1. The specifications and drawings for Invitation No. DACW64-02-B-0032, Public Facilities, Non-Overflow Dam, Wallisville Lake, Trinity River and Tributaries, Texas, advertised 2 August 2002, and for which bids are to be opened on 4 September 2002, are hereby modified as follows:

**TRINITY RIVER AND TRIBUTARIES,  
TEXAS, WALLISVILLE LAKE, NON-  
OVERFLOW DAM, PUBLIC FACILITIES**

(To Accompany Amendment No. 0001 to Invitation No. DACW64-02-B-0032)

| DRAWING NUMBER: <b>C-11</b><br>SHEET: 11 OF 35 FILE NO. TRIN 201-106  |   |

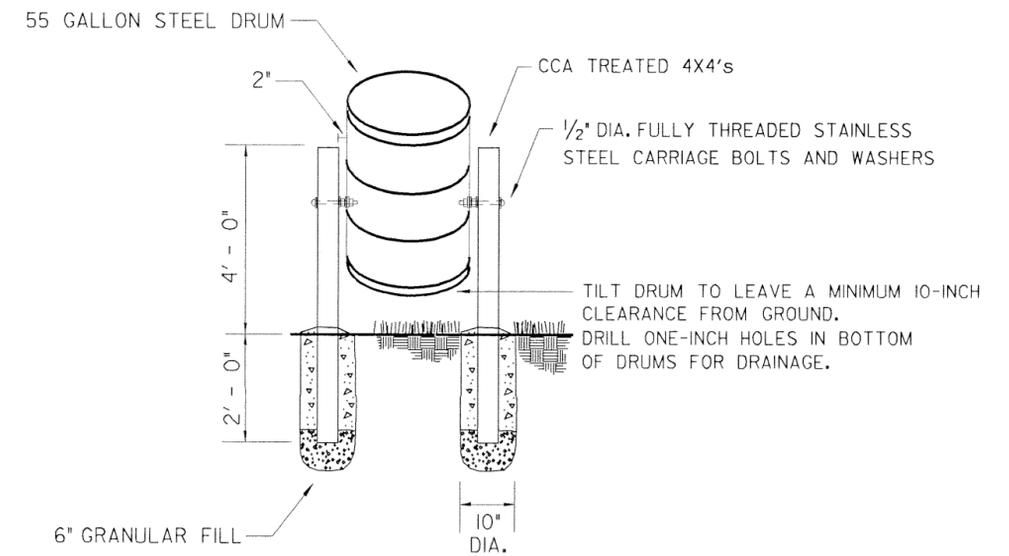
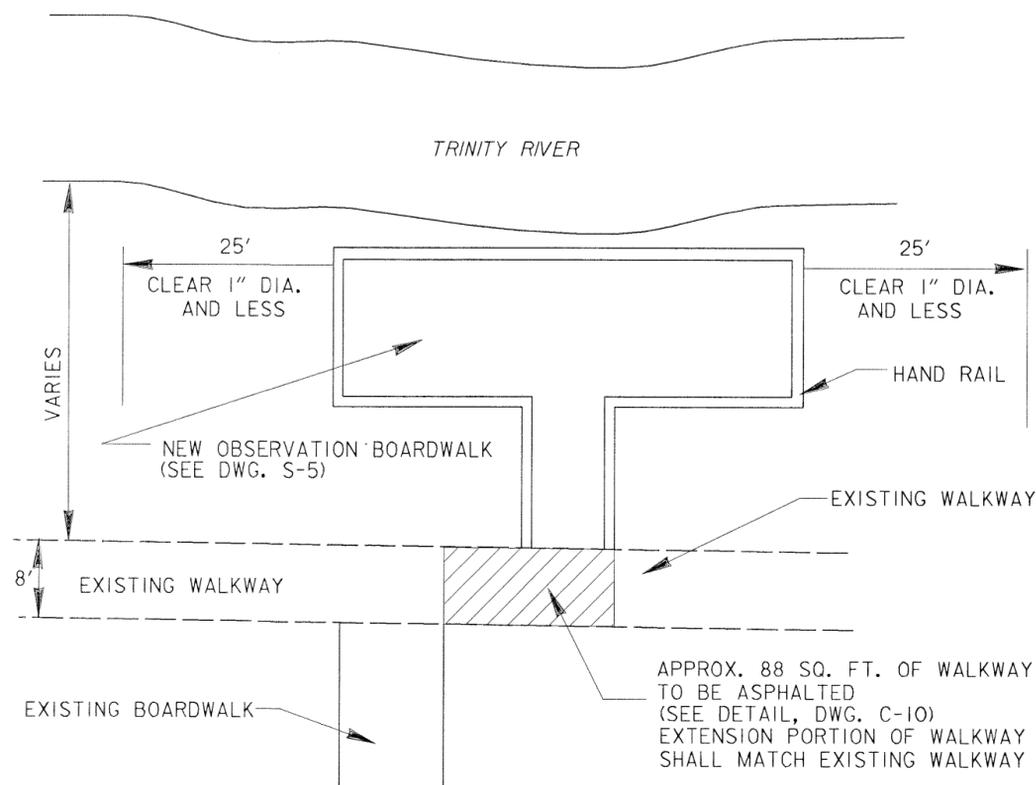
(9) Drawing No. C-11. - The enclosed "DRAWING NO. C-11" supersedes that issued with this Invitation.

| AMEND 1   | 8/14/02   | CHANGE TEXT AND BORROW EXCAVATION                                    | E.S.R.      |

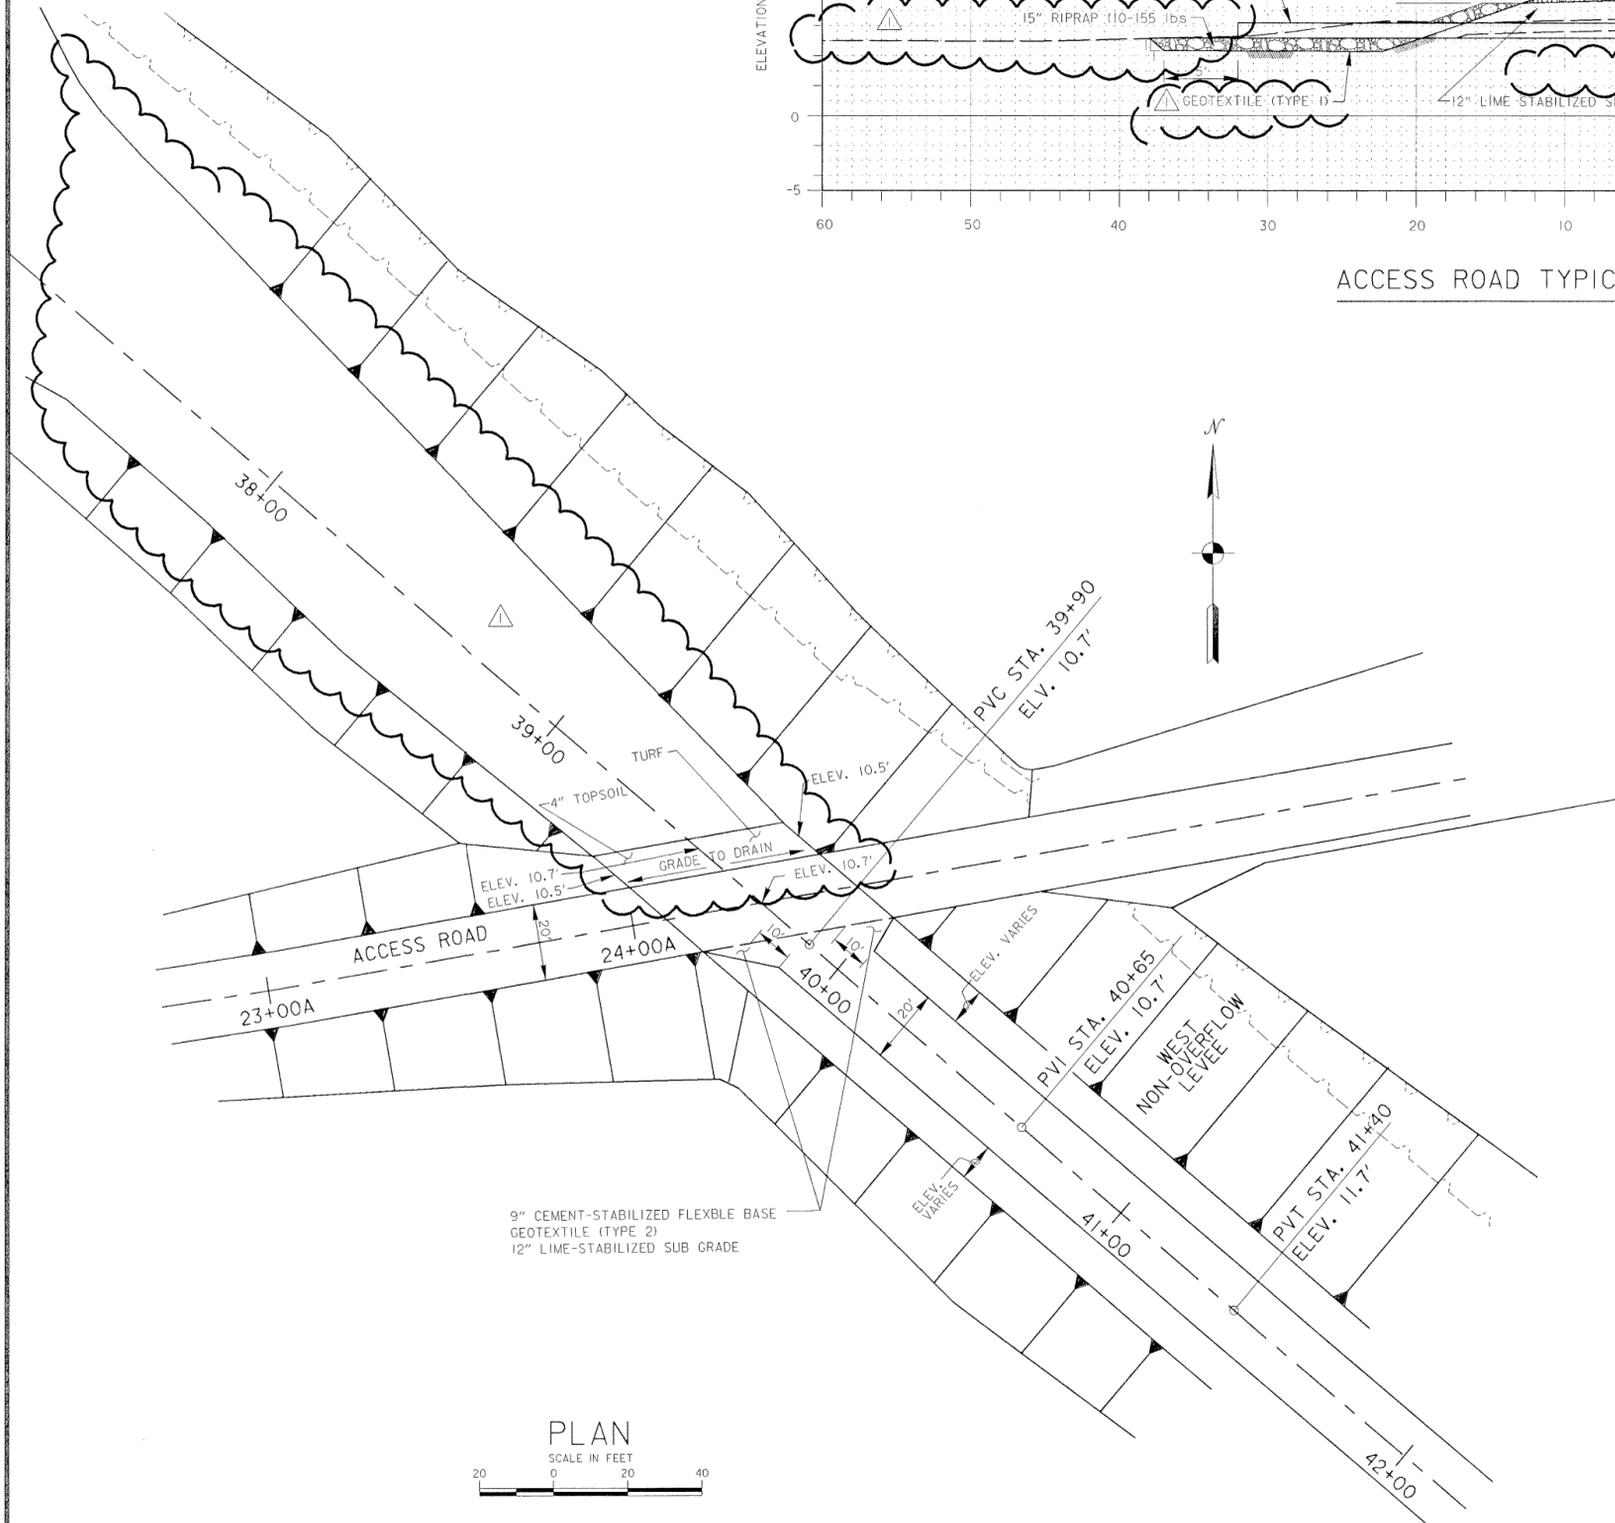
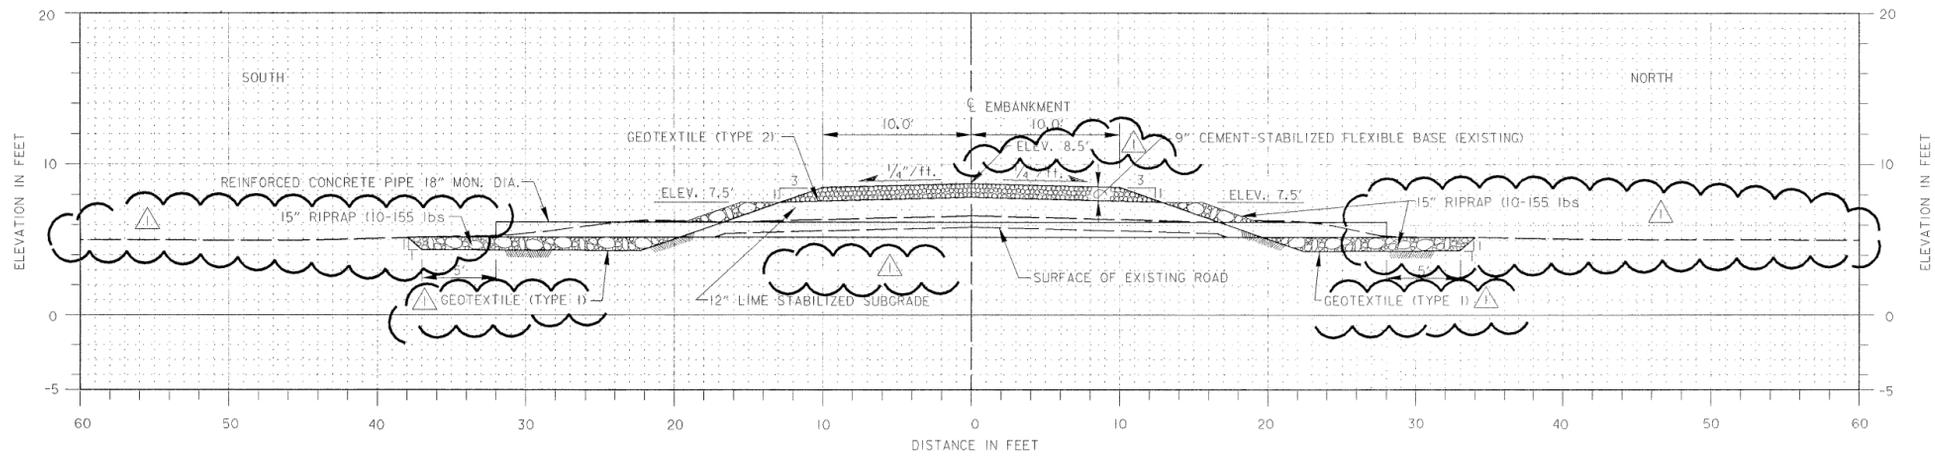
(17) Drawing No. F-4. - The enclosed new "DRAWING NO. F-4" supersedes that issued with this Invitation.

| Prepared under the direction of<br>Leonard D. Waterworth, Col., C.E.,<br>District Engineer                          |         | DRAWING NUMBER<br><b>F-6</b>   |        |

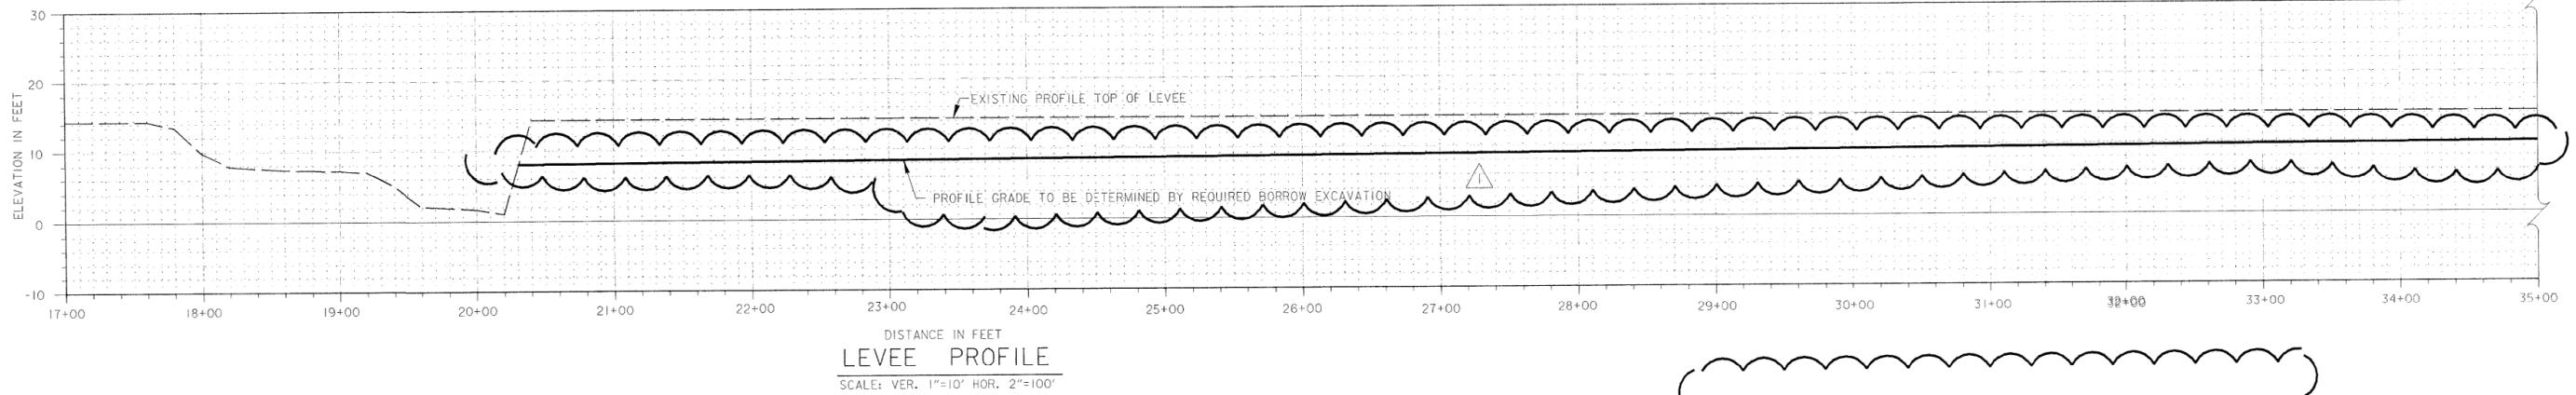
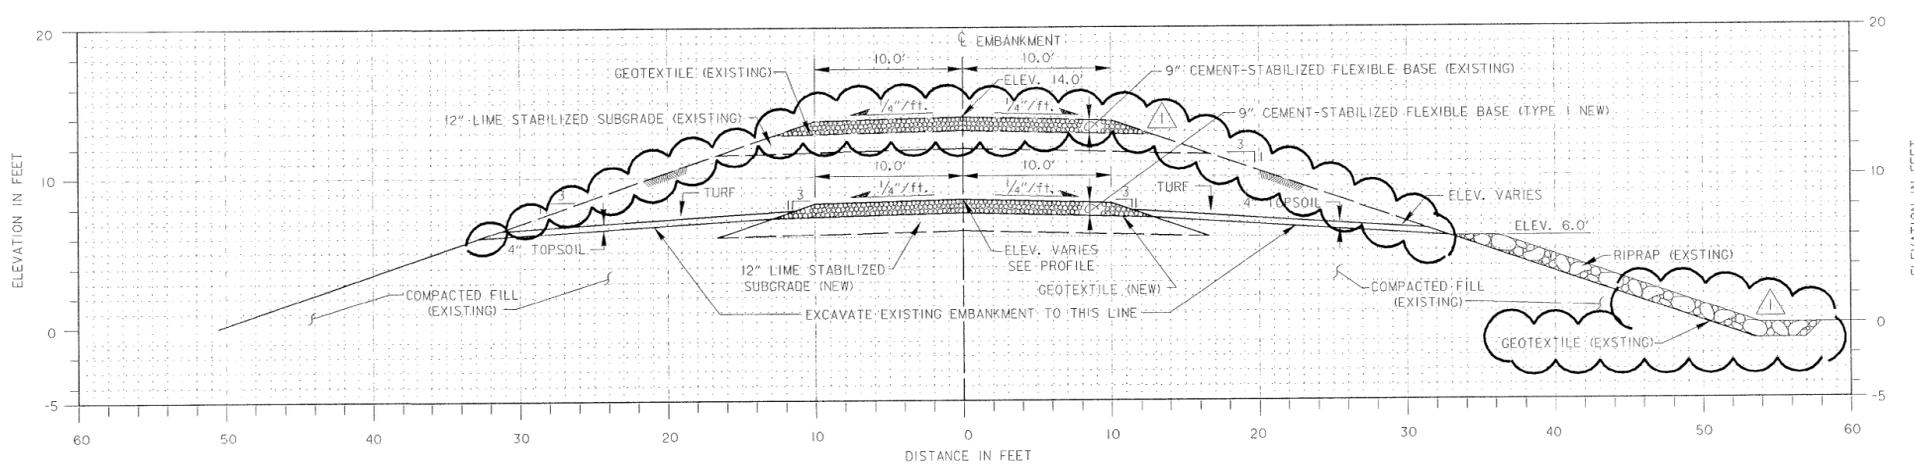
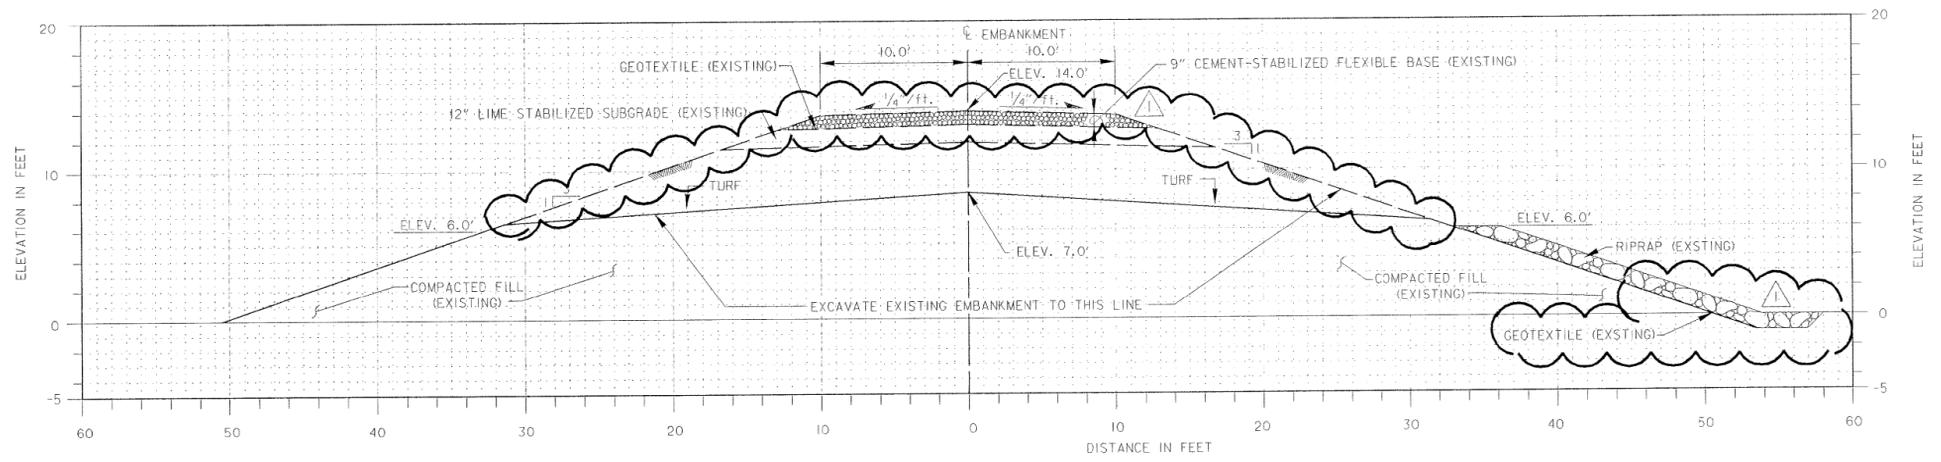
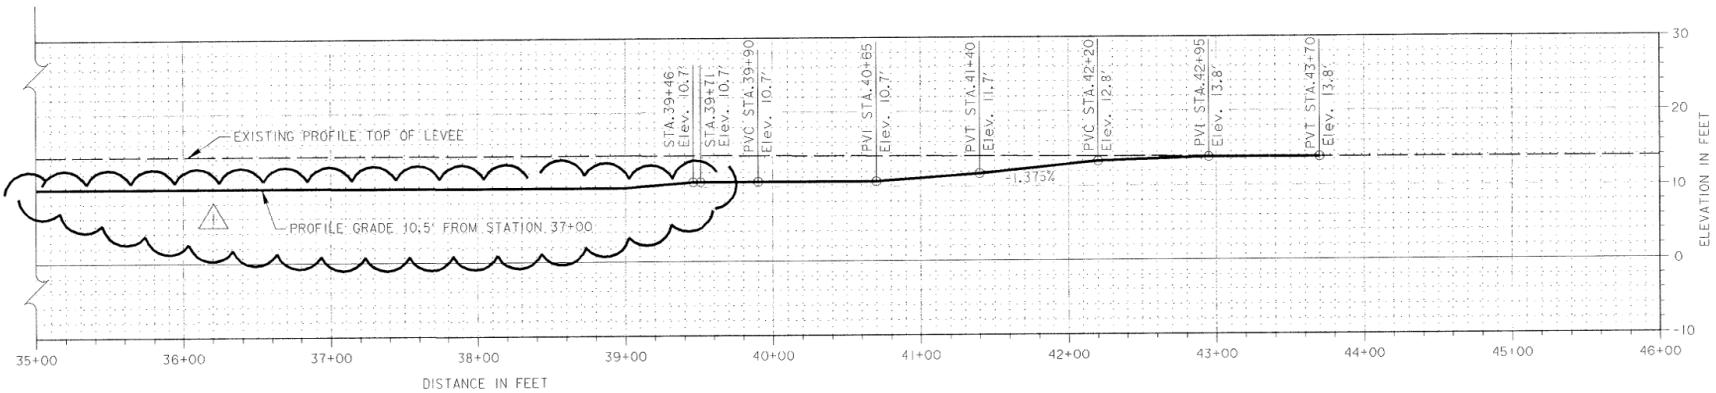
(18) Drawing No. F-6. - The enclosed new "DRAWING NO. F-6" supersedes that issued with this Invitation.

| AMEND 1   | 8/14/02 | CHANGE TEXT AND RIPRAP AT END AND PROFILE GRADE AND LINE OF EXISTING ROAD                                | E.S.R. |
